VVTA IFB 2019-14 CHARGEPOINT BUS CHARGER INSTALL ADDENDUM NO. 1

Tuesday, May 28, 2019

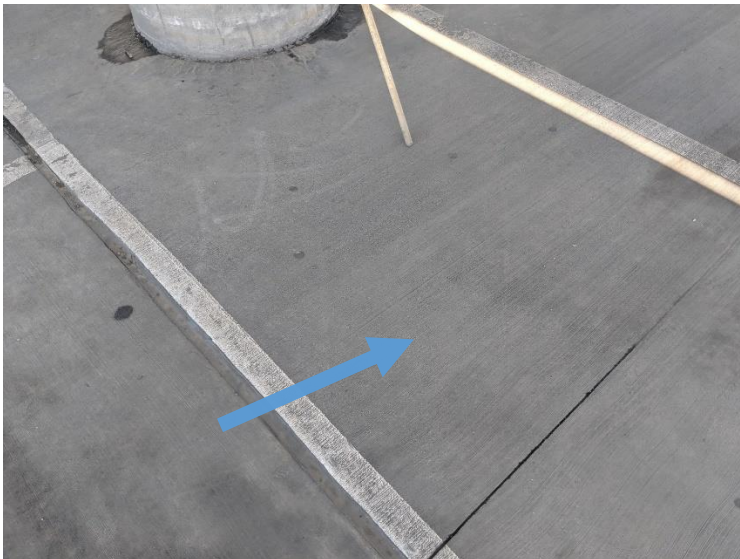
Q4: "Can I get overhead pictures of the existing site and location of where the charger will be set?"

A4:
